AMENDMENTS TO THE DRAWINGS

REMARKS

Applicants' invention is directed to set top boxes for receiving and processing digital data. As defined in independent claim 1, the set top box is comprised of a tuning component for receiving a digital transmission and producing at least one channel having digital data. An A/V/D unit is also provided that processes each at least one channel. Independent claim 1 further defines a processing component, including a browser for browsing interactive content, wherein the processing component solely provides control functionality and processor requirements for each component in the set top box. A unified memory, having access solely controlled by the processing component, satisfies the memory requirements of each component in the set top box. Lastly, the processing component is configured to dynamically use the unified memory for components of the set top box according to their respective needs.²

FIG. 3

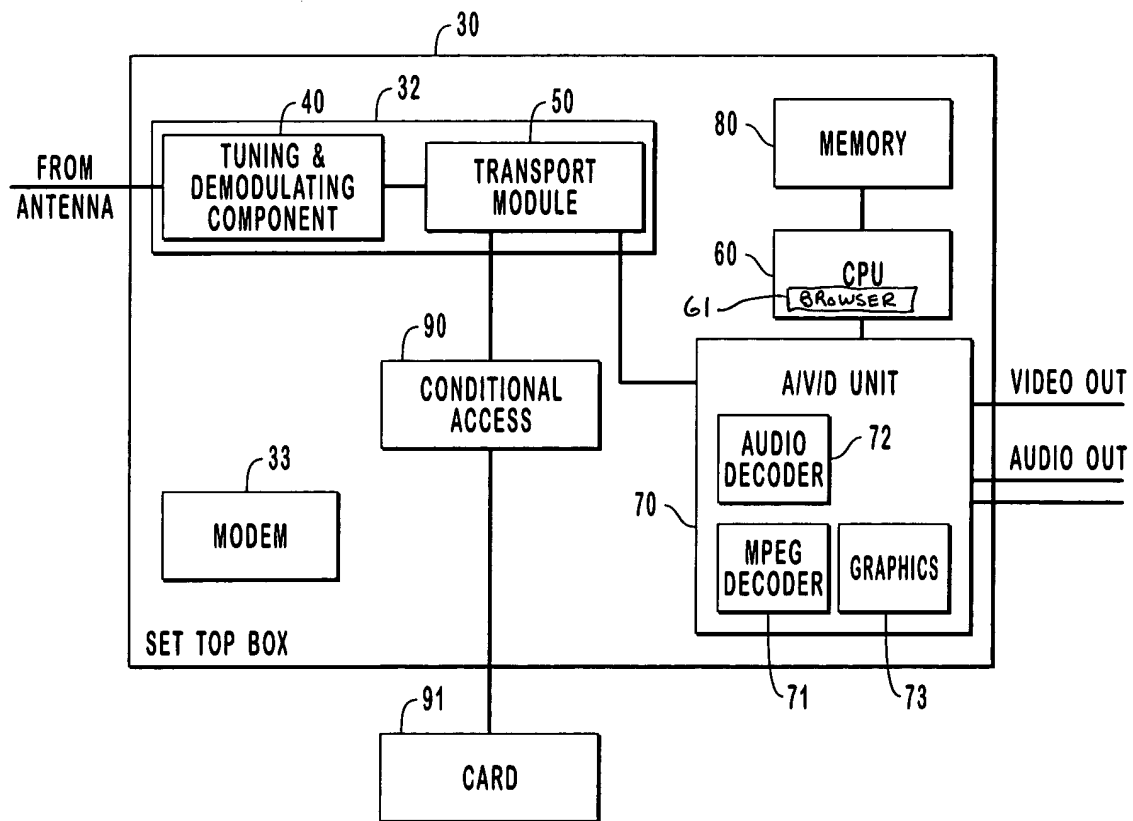
In order to comply with 37 CFR 1.83(a), Figure 3 has been amended to show a browser 61 included in CPU 60. Support for the amendment to Figure 3 is found at least at page 11, lines 20-21, page 12, lines 14-15, page 17, lines 3-4, and page 19, lines 19-21 and in the originally filed claims 1 and 8.

FIG. 4

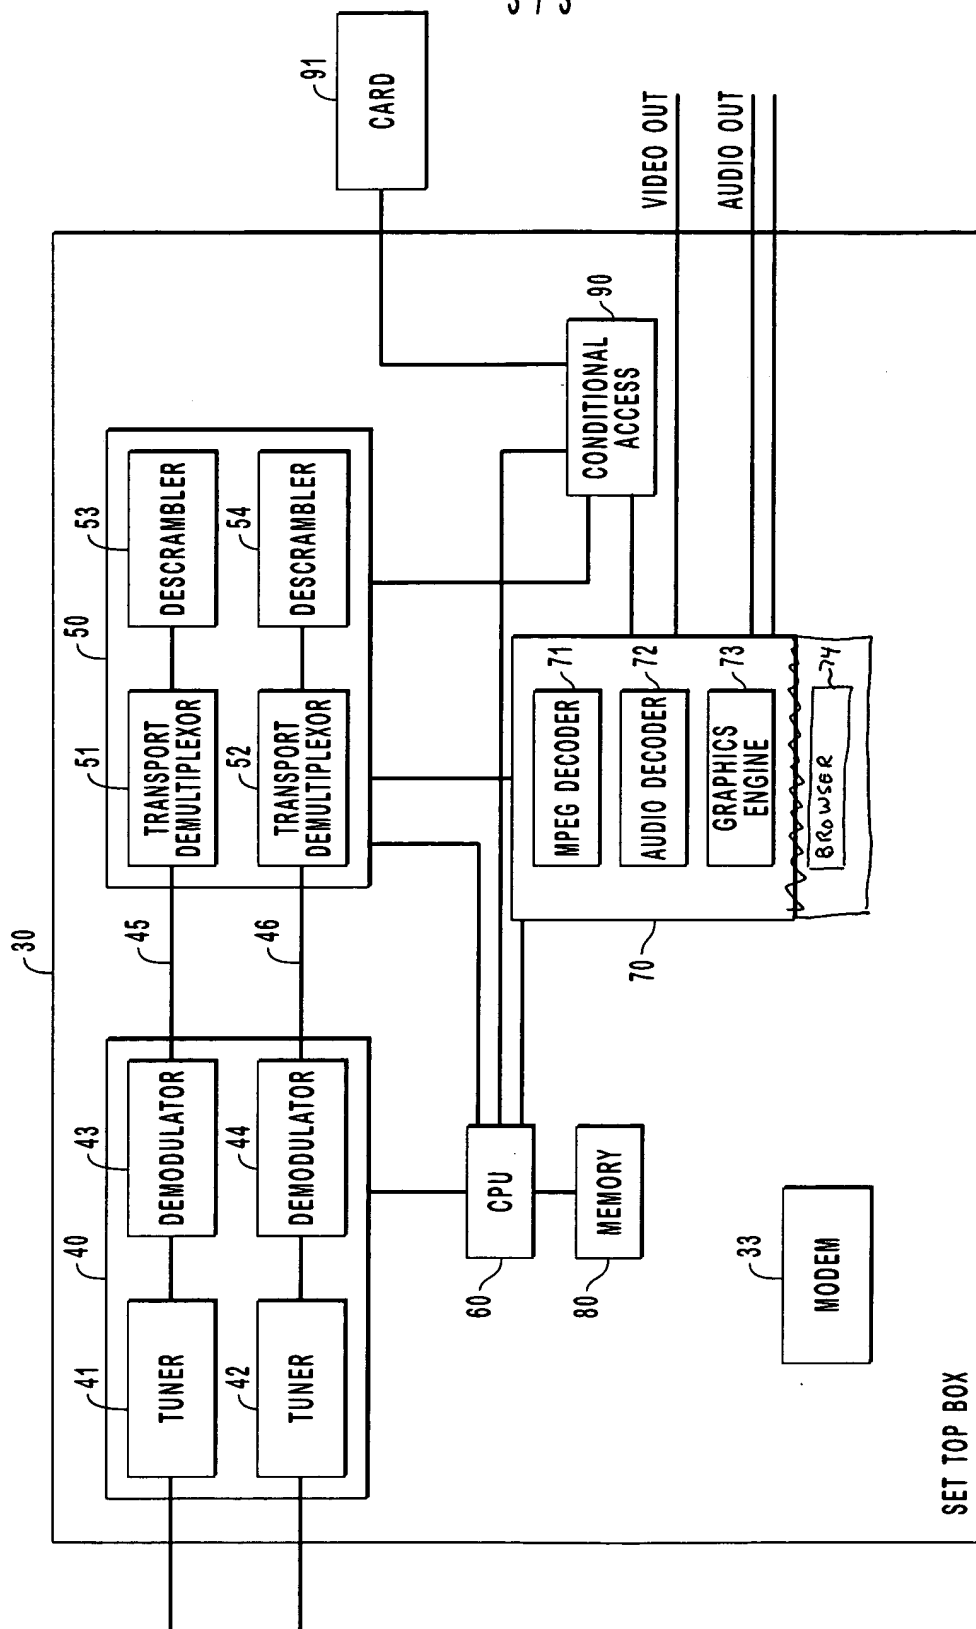
In order to comply with 37 CFR 1.83(a), Figure 4 has been amended to show a browser 74 included in A/V/D unit 70. Support for the amendment to Figure 4 is found at least at page 12, lines 16 -17, page 17, lines 3 – 4, and page 19, lines 19 – 21 and in the originally filed claim 18.
